COMMUNITY DEVELOPMENT DEPARTMENT
501 Delta Avenue ♦ Marysville, WA 98270 ♦ (360) 363-8000

Re: PA24-003 – Minor PRD – Technical Review 1

Figure 1. Tall retaining walls must be terraced with landscaping as depicted below.

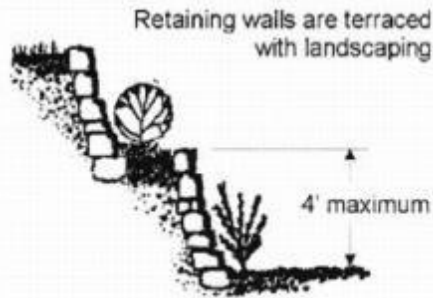
3. Pursuant to [MMC 22D.050.030](#)(4)(e), if retaining walls taller than four feet are used, and are visible from the street or adjacent property, they shall be terraced so that no individual segment is taller than four feet. Any walls ultimately permitted exceeding 4 feet shall comply with these requirements. Walls between lots 11 and 13, 12 and 14, 18 and 15, and adjacent to lots 6 and 29 shall meet these requirements. Please provide details/sections of the proposed walls.

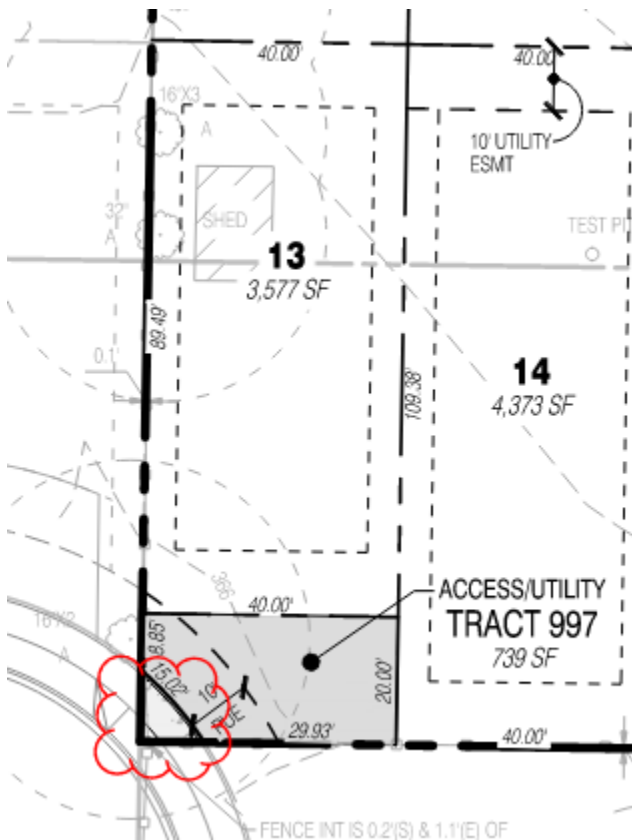
7. Building setbacks shall be measured from the edge of the temporary cul-de-sac. Please revise setbacks on lots 23, 24 and 26 accordingly.

7.1. The setback/building envelope on lot 24 shall reflect the access easement for lot 25.

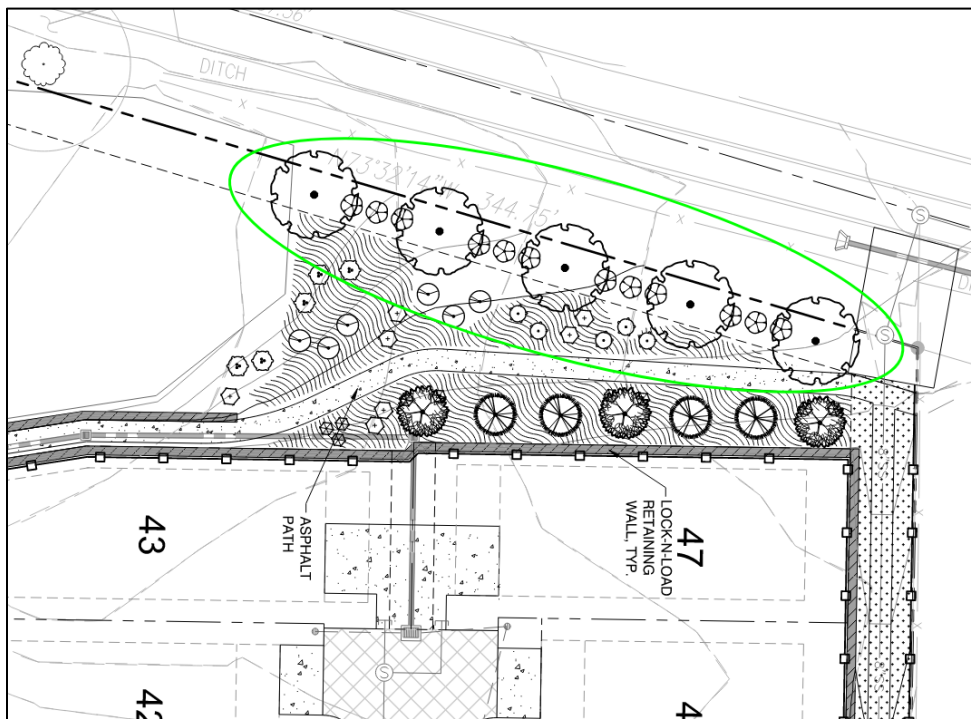
8. Prior to recording the **FINAL BSP** the applicant shall be required to provide **FINAL** restrictive covenants as required by [MMC 22G.080.120](#) and including provisions to address parking enforcement, together with a statement from a private attorney as to the adequacy of the same to fulfill the requirements of the PRD code.
9. All lots less than 5,000 square feet shall comply with the Small lot single family dwelling development standards outlined in [MMC 22C.010.310](#).
10. Language regarding dedication and construction of ROW improvements in Tract 997 (see area clouded below) shall be provided on the plat map.
